# COMMISSION OF ARCHITECTURAL REVIEW

## APPLICATION FOR CERTIFICATE OF APPROPRIATENESS

Address 10-12 East Broad Street

Re: 10-12 East Broad Street  
Part 2 Response  
DHR # 2016-167

THIRD FLOOR  
DEMOLITION PLAN

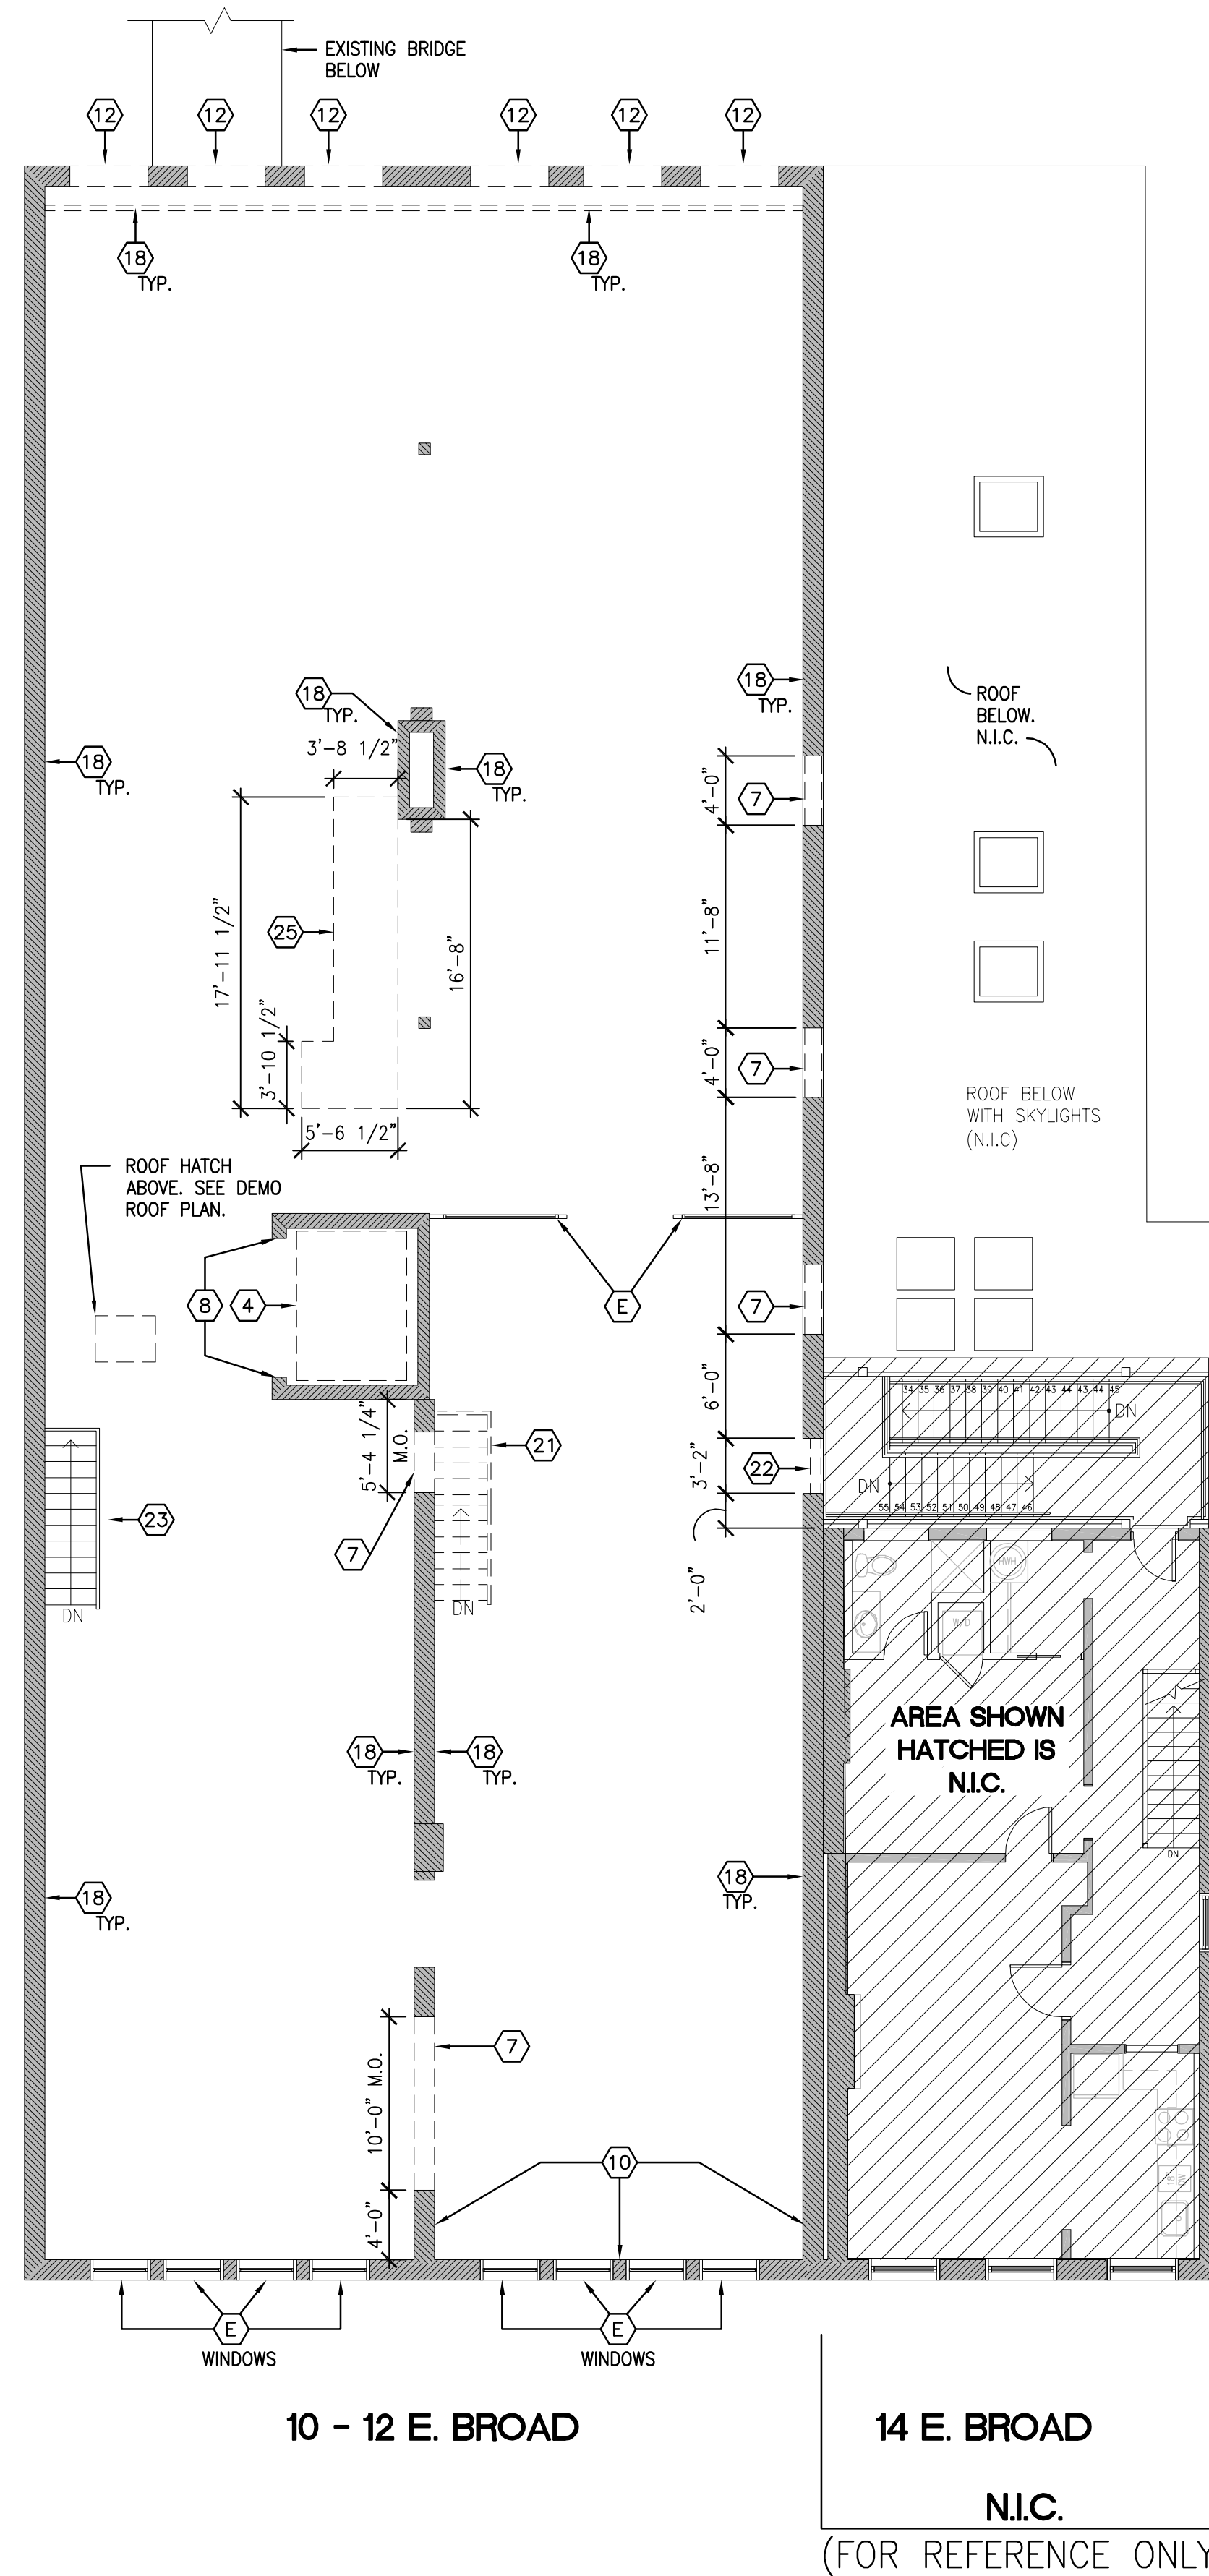
**Historic Partition Third Floor:** Please install a semi-transparent film on the glass of the historic partition on the third floor instead of spray-painting the glass black. This will provide privacy for the new bedroom while also retaining some light transmission through the glass, as there would have been historically.

5. **Historic Partition Third Floor:** Please install a semi-transparent film on the glass of the historic partition on the third floor instead of spray-painting the glass black. This will provide privacy for the new bedroom while also retaining some light transmission through the glass, as there would have been historically.

**1 SOUTH ELEVATION - PROPOSED**  
SCALE: 1/8" = 1'-0"

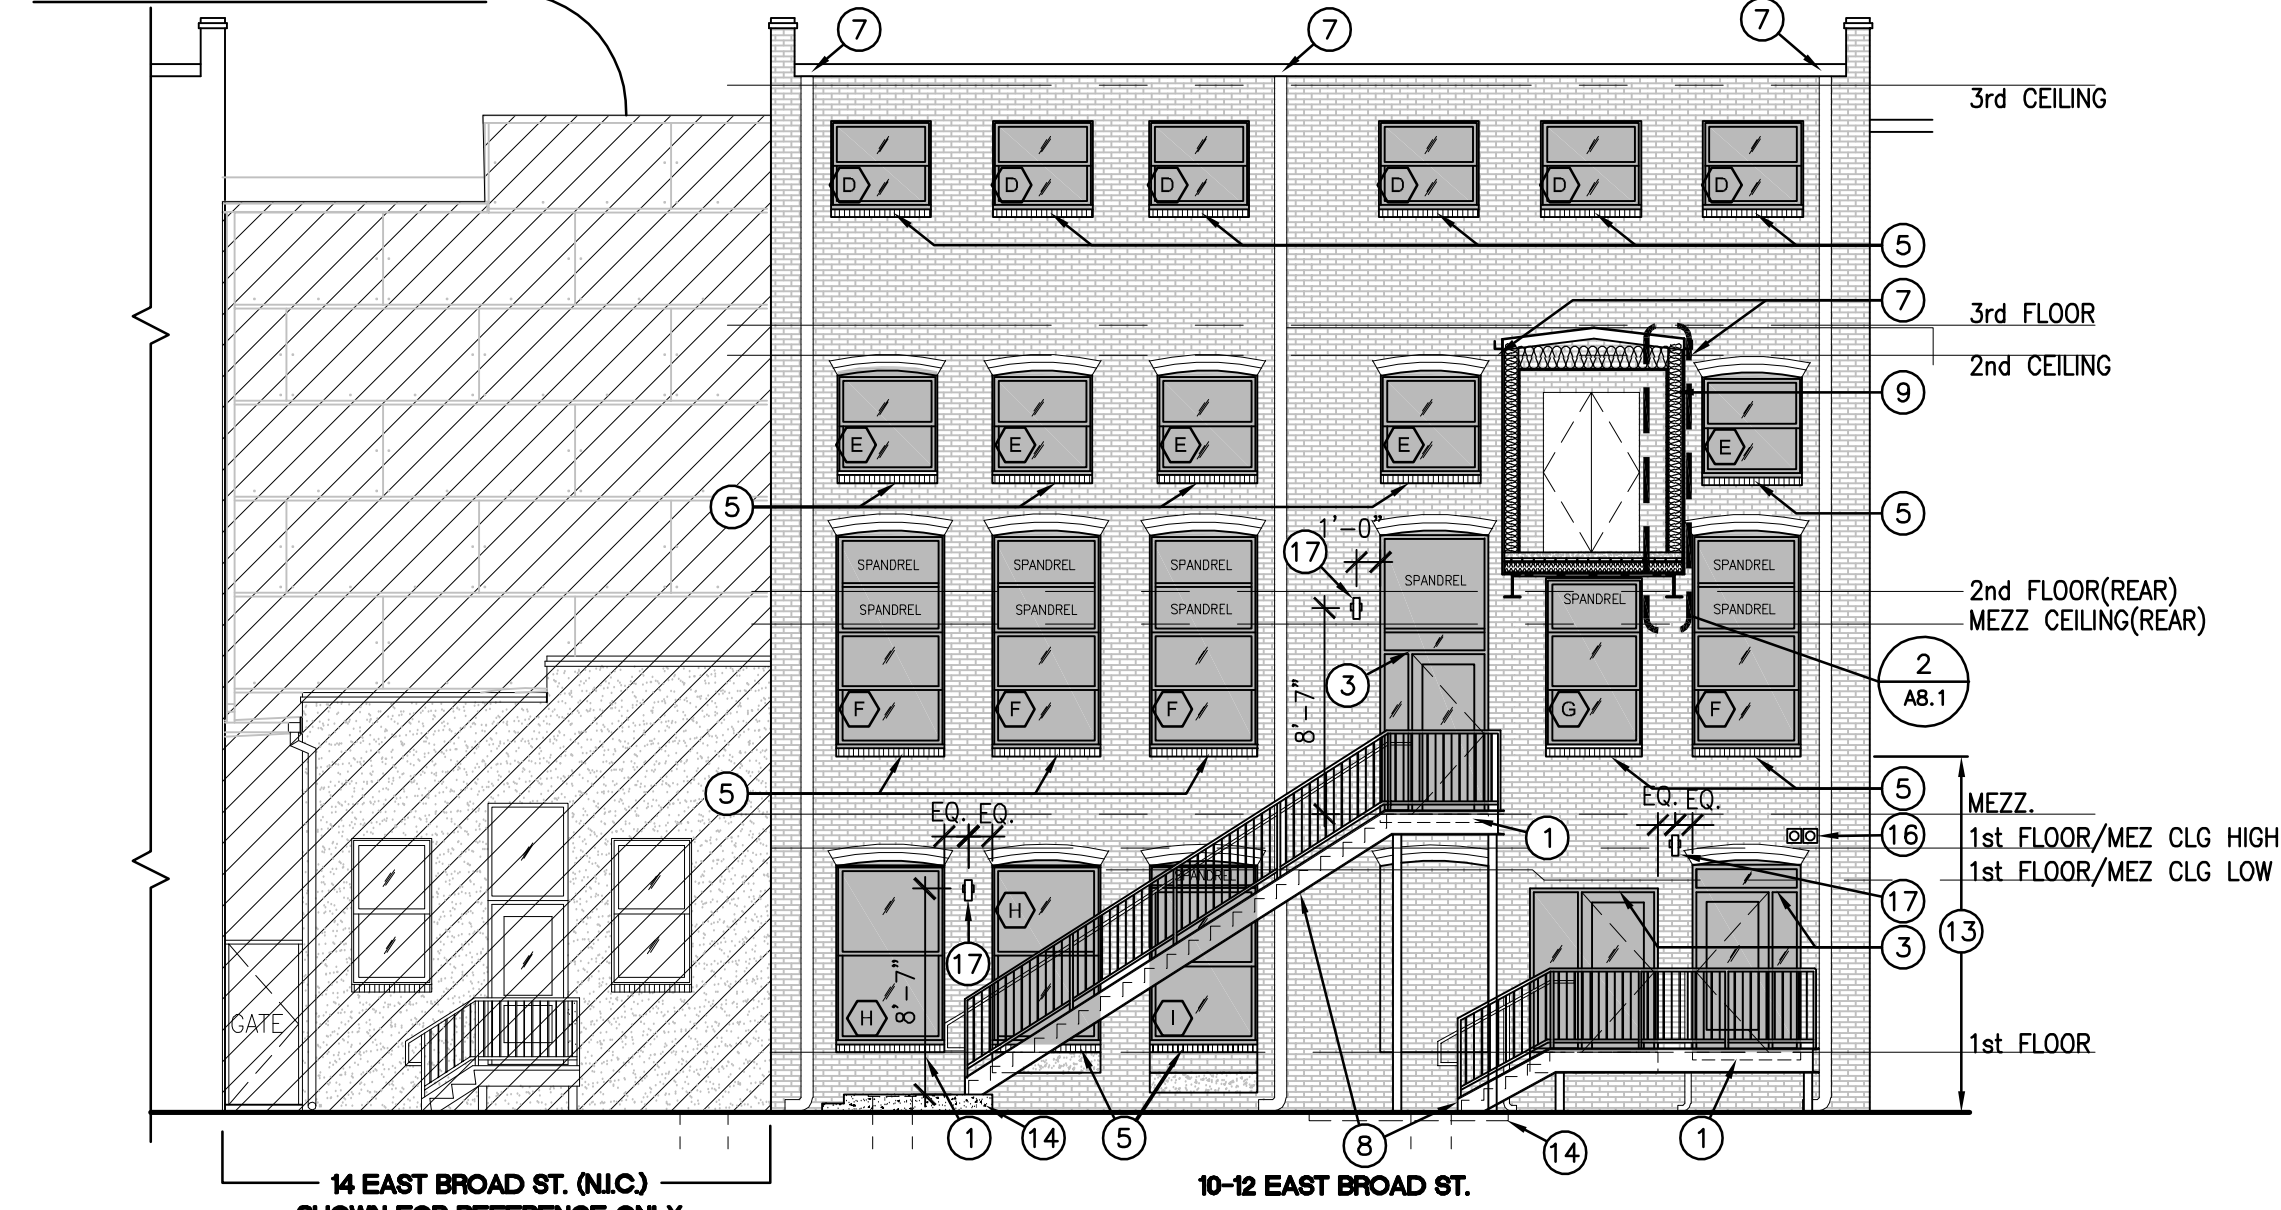
**Storefront:** In order to ensure the storefront meets the *Standards*, please provide detailed, dimensioned drawings of the proposed replacement storefront. In addition, please submit the referenced historic photo showing two separate recessed entrances centered in the two primary bays of the south elevation that you are using as justification for the changes you are proposing.

1. **Storefront:** In order to ensure the storefront meets the *Standards*, please provide detailed, dimensioned drawings of the proposed replacement storefront. In addition, please submit the referenced historic photo showing two separate recessed entrances centered in the two primary bays of the south elevation that you are using as justification for the changes you are proposing.
2. **Basement Moisture Management:** Please provide more detail on how you proposed to conduct moisture management in the basement.
3. **Waist Lines in the First Floor Commercial Spaces:** Please provide more detail on the proposed waste lines that will be located within the commercial spaces. Submit a general systems plans that shows where these waste lines will be located so we can better understand how the introduction of these lines might affect these historic commercial spaces.
